City of San Antonio

Re: **Oliver Ranch (Amendment)** **MDP # 662-F**

The City Staff Development Review Committee has reviewed the **Oliver Ranch** Master Development Plan (Amendment), **MDP # 662-F**. Please find enclosed a signed copy for your files. Your plan was approved for acceptance, however, please note the following conditions:

OLIVER RANCH
PUD / POADP PLAN

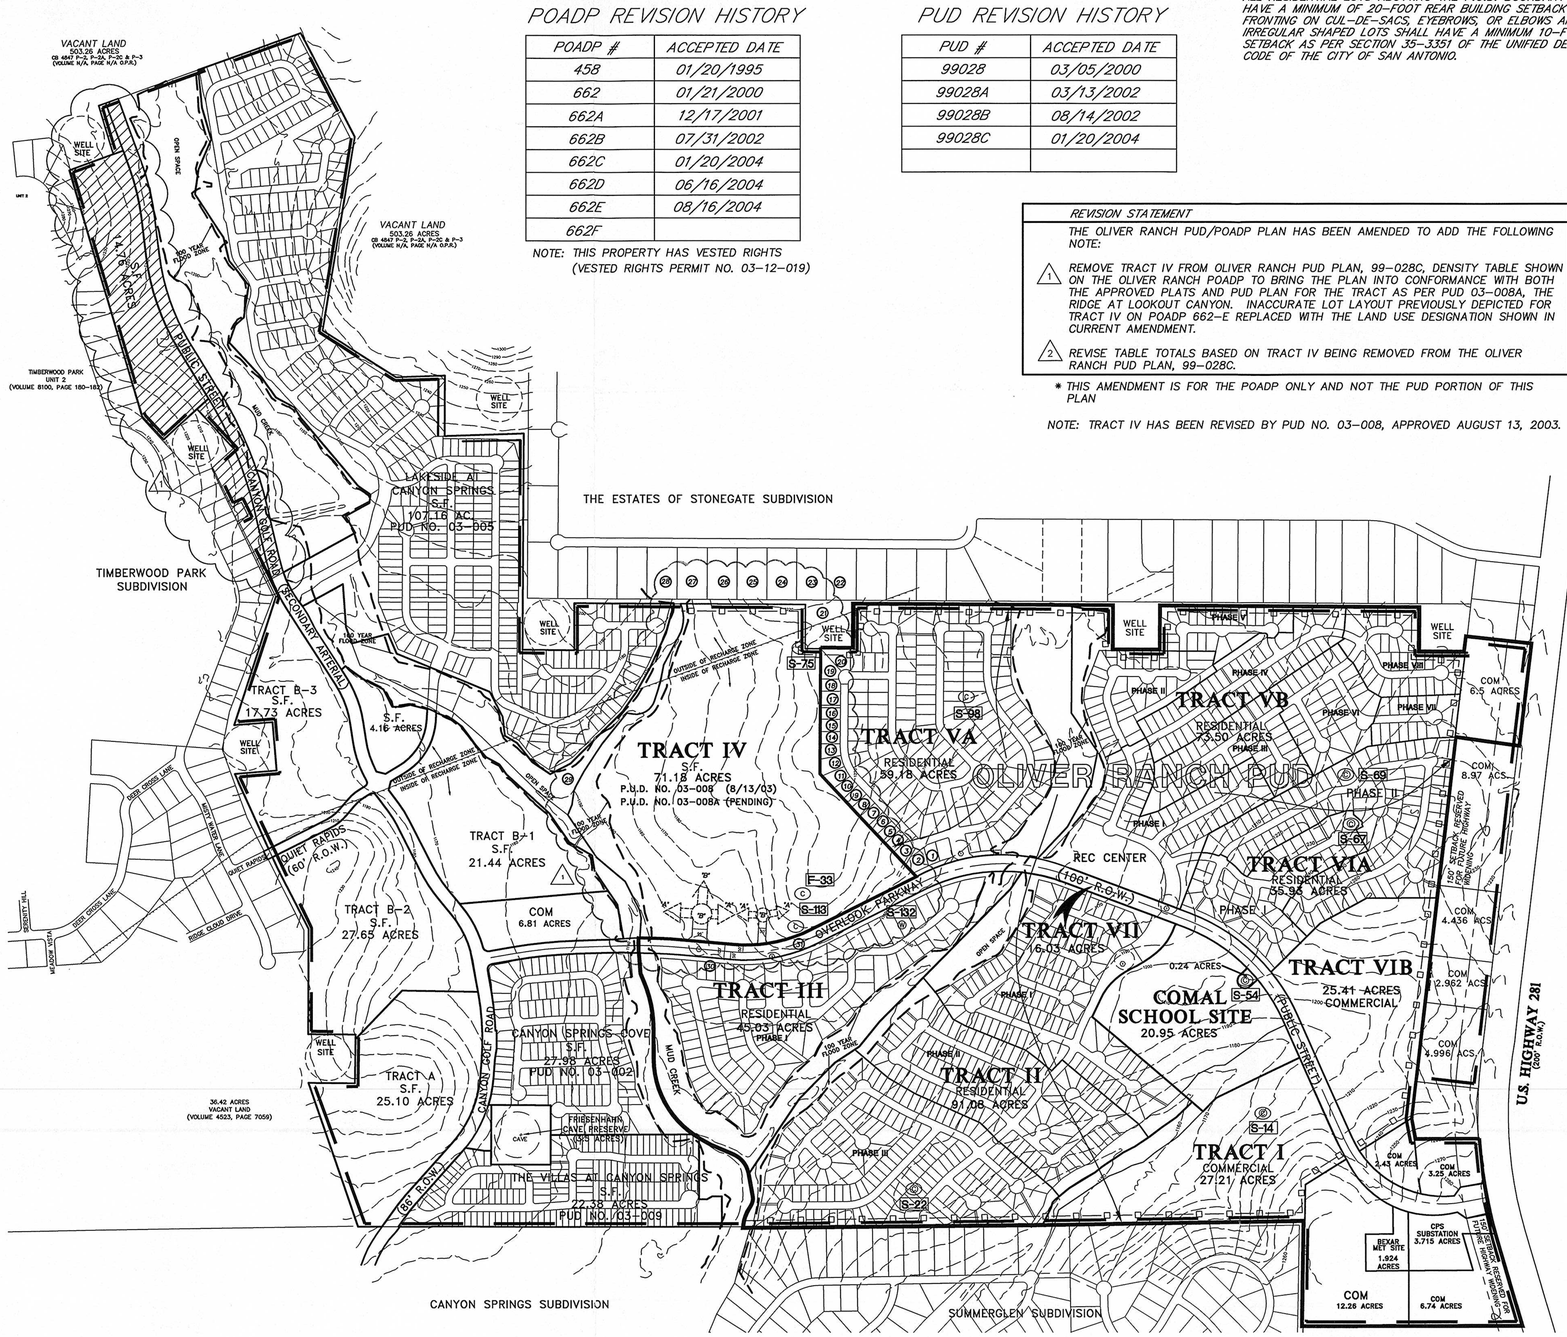
In consideration of public safety and convenience, excessive grades by reason of topography should be avoided in street layouts and arrangements. Any access and R.O.W. issues along state facilities will need to be resolved with the **Texas Department of Transportation (TXDOT)**. For information about these requirements you can contact TXDOT at (210) 615-5814.

- It is understood that this Master Development Plan is a conceptual plan and all regulations will be addressed at time of platting. Bexar County reserves the right to address driveways, street design, sight distance, ADA requirements, and drainage and floodplain issues at time of platting.

- In accordance with the Aquifer Protection Ordinance No. 81491 for Plat Certification, the following condition shall be met:
- 100 year Flood Plain Shown and Buffering (if applicable)
- Sensitive Recharge Features and Buffering (if applicable

- A Water Pollution Abatement Plan or Contributing Zone Plan must be submitted to and approved by the Texas Commission on Environmental Quality (TCEQ) prior to construction.

- According to the plans submitted some sensitive features will be preserved per TCEQ. Aquifer Protection Ordinance # 81491, section 34-913 & section 34-914 floodplain buffering may be required. Any existing well(s) found on site shall be plugged by the property owner in accordance with Saws regulations. For plugging procedures please contact Monty McGuffin at 233-3546.

All platting shall comply with the Unified Development Code (UDC), Master Plan, and Major Thoroughfare Plan for the City of San Antonio. It will be expected that all of the property depicted in your Master Development Plan to include floodplains, drainage areas, and open space shall be platted. It is suggested to work closely with the school district, so they can plan accordingly.
